Product Change Notification
Software Release Notice

MultiConnect® rCell 100 Series Cellular Routers

mPower™ Edge Intelligence mPower 5.2 Firmware Available

Product Change Notification Number
PCN 06022020-MTR-001

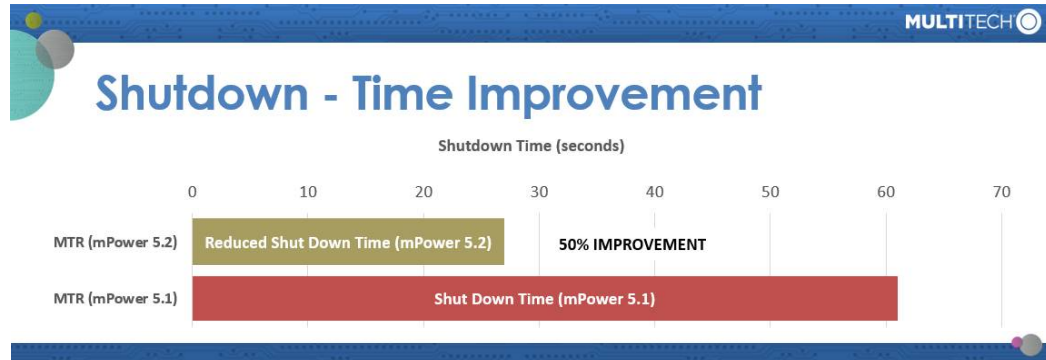
1. Reduced Boot Time Previous versions of mPower resulted in longer boot times. mPower 5.2 includes new features and optimization that decrease the device boot time up to 25% [GP-256, GP-360, GP-362, GP-363, GP-364]

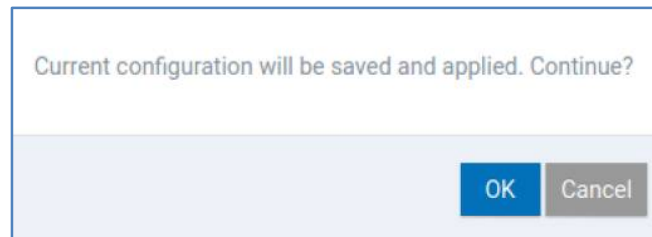
2. Shutdown Time Optimization: When restarting a device, the total time to reboot also includes shutdown time. Previous versions of mPower resulted in longer shutdown times. mPower 5.2 has been updated to reduce shutdown time. MTR mPower shutdown time has been shortened by 50%.

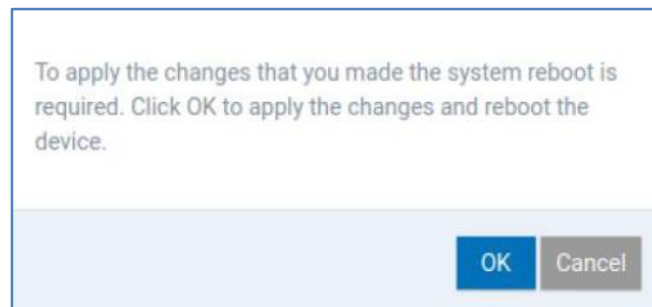
3. Save and Apply Configuration Settings without Restarting: Previous versions of mPower required a device reboot for most system configuration settings. mPower 5.2 has been updated to save and apply many configuration settings without the need to restart. In these cases, the user will be presented a “Save and Apply” button after making configuration settings. If “Cancel” is selected, changes are not saved. [GP-339]
